RE: **Copper Townhomes
Grading & Drainage Plan
Engineer's Stamp Date 8-15-16 (File: K17D111)**

DRAINAGE AND TRANSPORTATION INFORMATION SHEET

RE: Copper Ave. Town House Condos, Drainage Plan (K17D111)

Copper Ave Townhomes - K17D111

<div>ENGINEER'S SEAL</div> <div></div> <div>Richard Dourte P.E. #10854</div>	Title: Copper Ave Townhouse Condos	DRAWN BY DATE
	GRADING AND DRAINAGE PLAN	DWG
	RHD Engineering, LLC 4305 Purple Sage Ave. NW ALBUQUERQUE, NM 87120 (505) 288-1621	SHEET # 3 of 6
		JOB # 787485

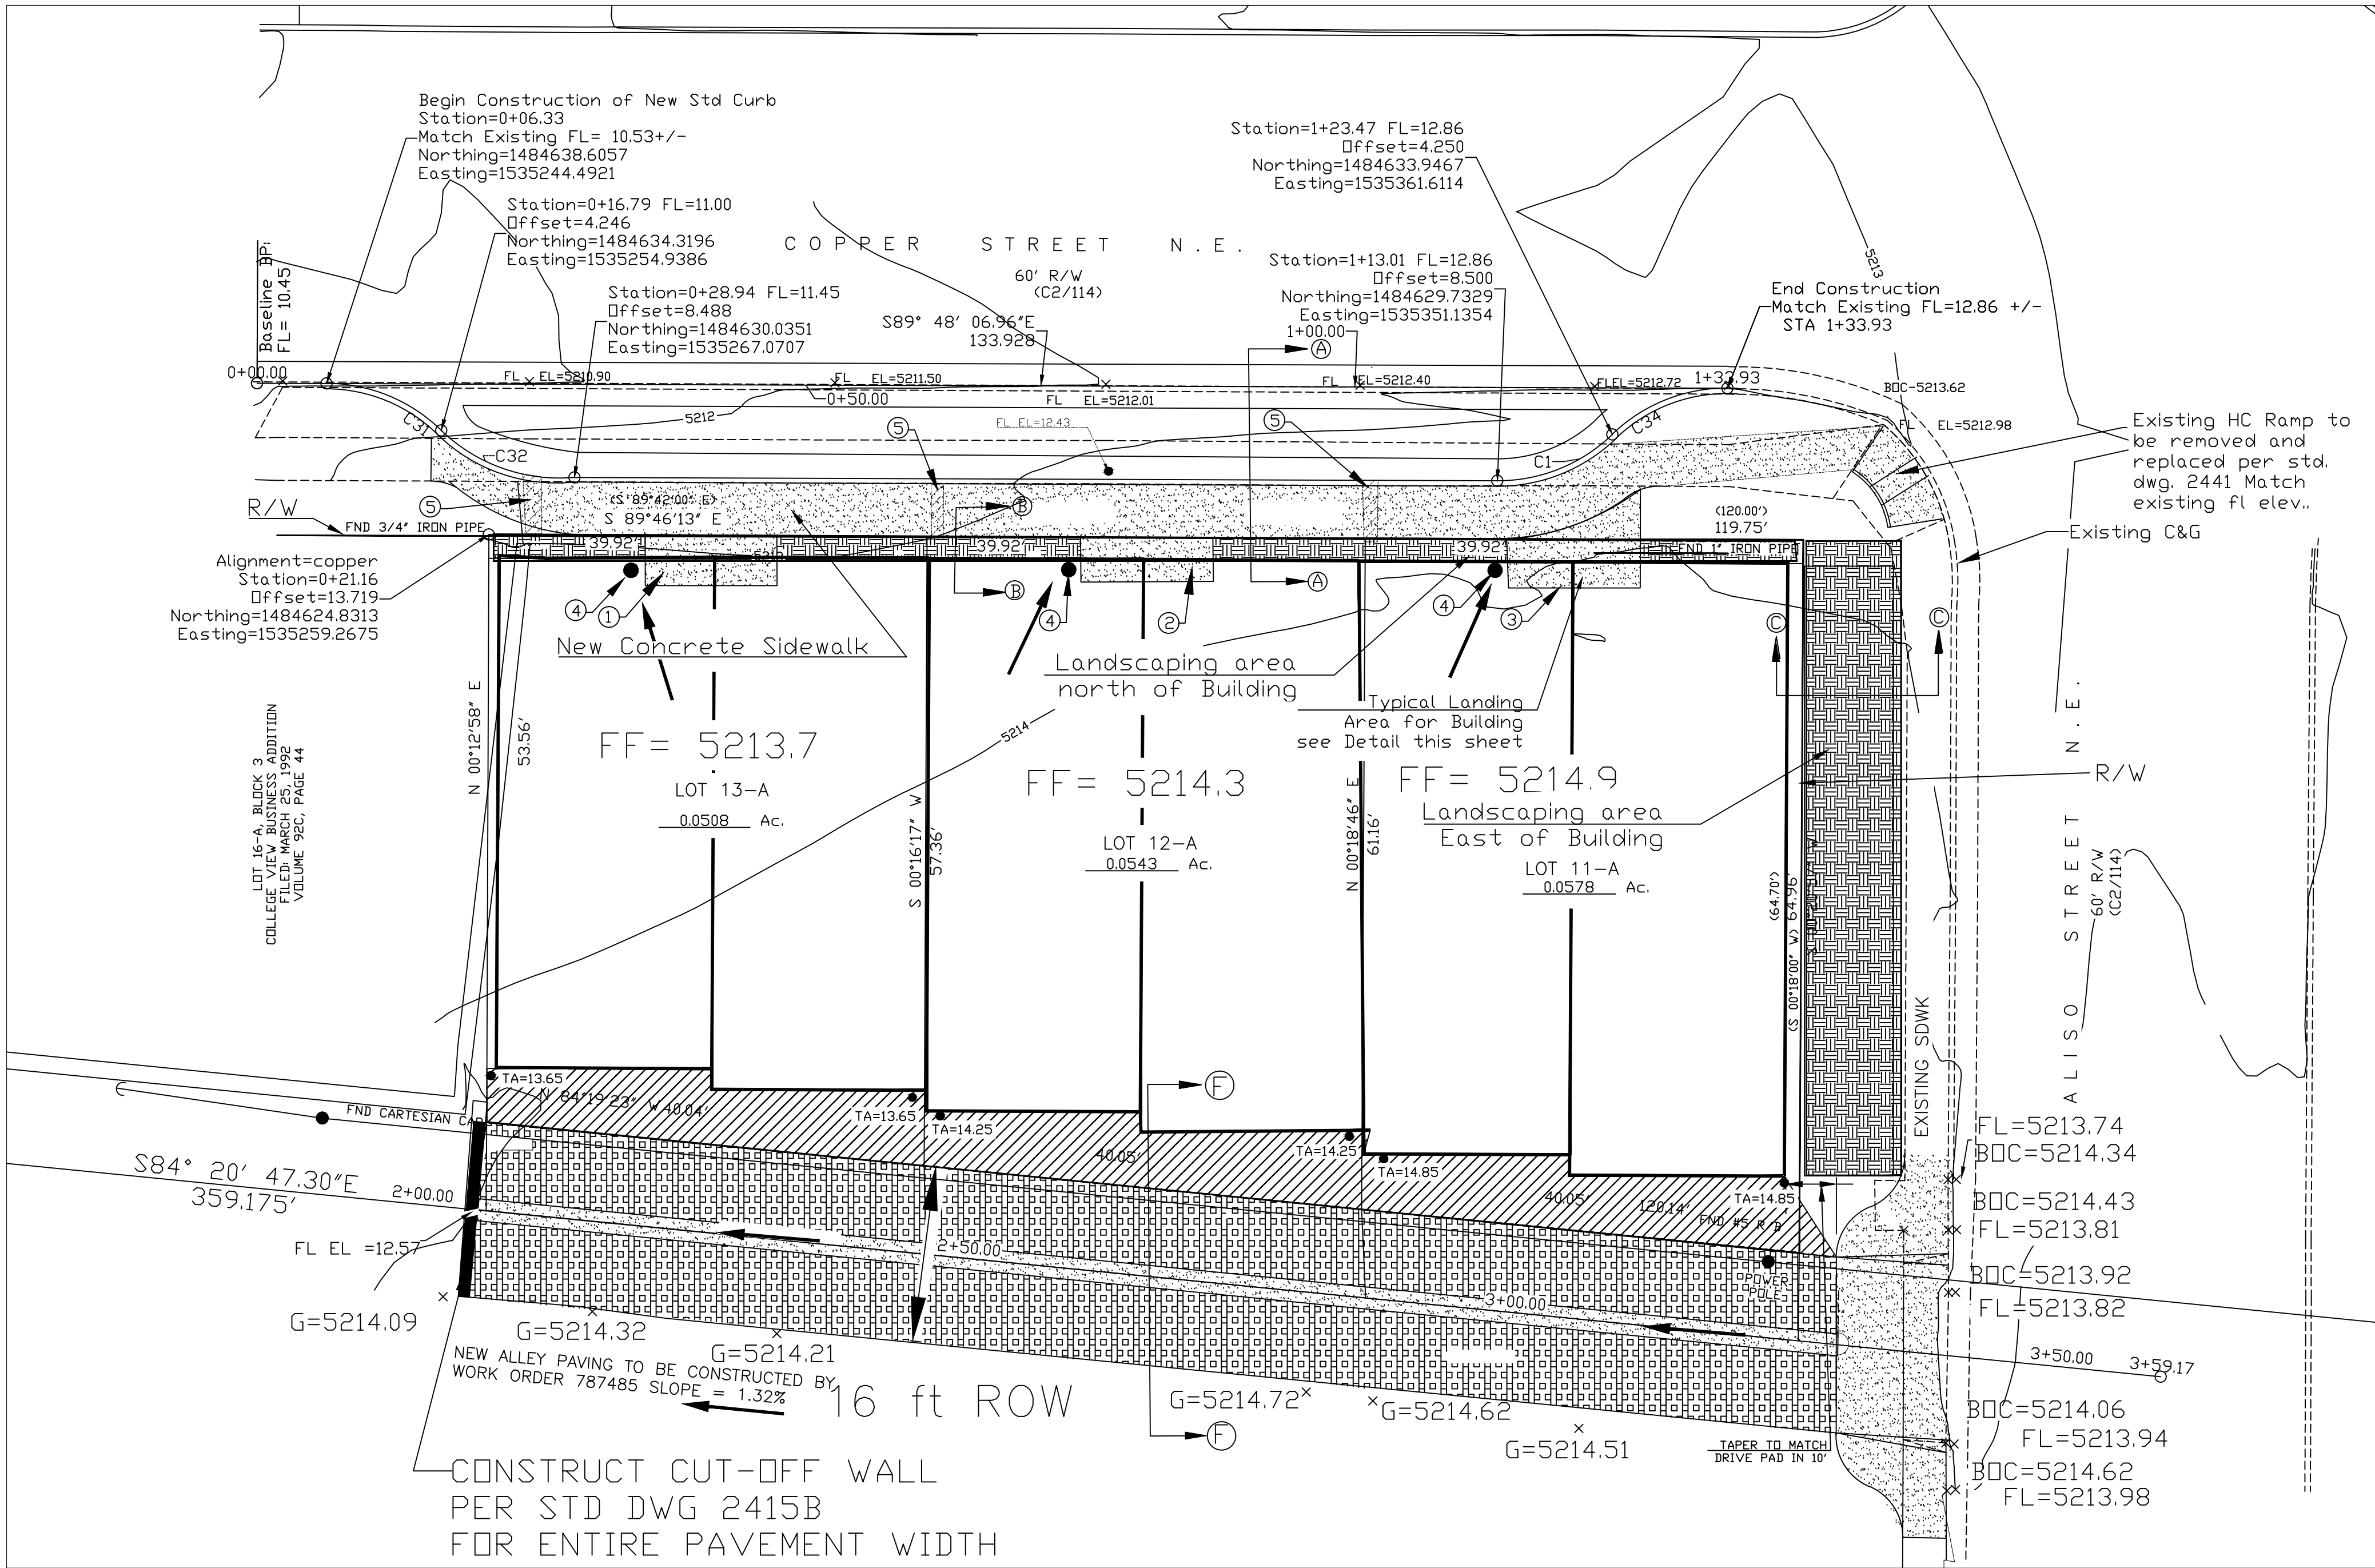
1. The plan continues to lack sufficient information for the Contractor to follow for several elements. However, given the small scale of the project, they can potentially be best addressed in the field. The construction of the private site work should be supervised by you or a representative to ensure that minor field corrections that will likely be needed are fully coordinated to prevent as-built condition issues that could delay the Certification for Occupancy:

- a. A wall appears to be encroaching into the proposed building on Lot 13-A.
 - b. There are dimensions shown that are floating on the plan without leader lines (39.92', 120.14', 40.05', etc).

- c. The building landing notes show a single elevation and it's not clear where it is to be set. Furthermore, consider incorporating a minimum slope to prevent nuisance ponding/ice patching near the building entrance, (the single elevation suggests that it is to be laid flat).

- d. The landscape buffers appear to be shown flat graded along the north face of the buildings; are they intended to drain? The sidewalk culverts have no build notes or dimensions, and they are offset from the apparent roof drain locations.

- e. Disconnected and broken line work implies that the electronic drawing might have issues that the Contractor will need assistance with in the field (if the contractor uses the electronic file for staking).

- f. Major elements of the project that are shown to be described in the DRC Set are not properly defined in the DRC Set (these items will need to be corrected on the DRC Set):
- i. There is little direction for the Contractor on how to lay out the horizontal geometry of the unattached sidewalk, and the dimension of the west tie in appears to be approximately 2.75 feet wide.
 - ii. The way the driveway on Aliso is drawn is not constructible.
 - iii. The edge of pavement to edge of pavement dimension for the alley section is 16 feet. The cut off wall is outside of this dimension along the southern edge, so it will be encroaching into the adjacent property.
 - iv. There is no direction on how to construct the 6" swale in the unimproved segment of the alley (to prevent the contractor from just dropping a blade through the middle of the alley).

1. Provide a lighter hatching for the landscaping and paved alley areas, the pen weight of those areas make the text underneath illegible to the contractor.

2. Provide additional detail of the surface/section proposed between the buildings and the alley. The TA elevations suggest asphalt, but it should be clarified, and the asphalt should be placed over a prepared base.

3. Show how the paved alley transitions from the full section 18' to the width of the driveway (i.e. how the edge curbing ties in to the driveway).
4. The section for the paved alley shows a width of 18', but the hatching on the plan view and the apparent property line make it seem like the 18' paved width doesn't fit in the right of way.

5. The alley section should include concrete edging on both sides of the road per the standard drawing.
6. Call out a cut off wall at the west end of the alley pavement section.

7. Show the location of roof flow discharge points. Roof flows are not allowed to discharge onto the surface of the sidewalk.
8. Show spot elevations to support the maximum 2% cross slope that is allowed along the sidewalk.

9. Show spot elevations around the concrete pads on the north side of the building.
 - a. Are stairs needed to access the building?

10. The parking aisle is shown with a 5% cross slope. Coordinate with Transportation Development because it appears to be too steep.
11. The sidewalk at the NE corner tie-in should provide a better horizontal transition to the wheelchair ramp. Furthermore, the width of the existing sidewalk should be coordinated with Transportation Development, since it is currently only 4' wide.
12. How are the right of way improvements to be completed? Mini Work Order? Work Order?
13. Minor comment: The plan references the standard drawings, but graphically the details should emphasize the max 2% cross slope on the sidewalk. Unfortunately we have seen some contractors point to the detail to excuse incorrect construction of the sidewalk.

1. Lighter hatching of the areas you referenced was incorporated in this plan.
2. The areas between the alley and the buildings are to be paved, this is indicated by hatching on the new plan.

3. The alley will be paved 16ft, the details including the transition are shown.
4. The alley width has been changed to conform to the existing r/w.
5. At DRC, it was determined that concrete edging was not needed on the north side of the alley.

6. A cut-off wall has been added.
7. Roof drains have been added to the plans, please see keyed note #4, sidewalk culverts have been added, please see note #5 .

8. A details showing the sidewalk and 2% cross slope to the landing for the building entrances has been added to the plan.
9. Finish top of concrete elevations for the building landing areas have been added, yes stairs are to be incorporated. The stairs are on private property, the doors open into the building, not into the public sidewalk, please see the detail that has been included on this plan.

10. The 5% cross slope has been reviewed by Transportation at a DRC predesign meeting.
11. This sidewalk transition will be reviewed by Transportation at DRC.

12. The alley construction and the improvements within Copper ave. are to be done by work order, City Project no. 787485.
13. The detail for the street x-section now includes the 2% slope being shown for the sidewalk.
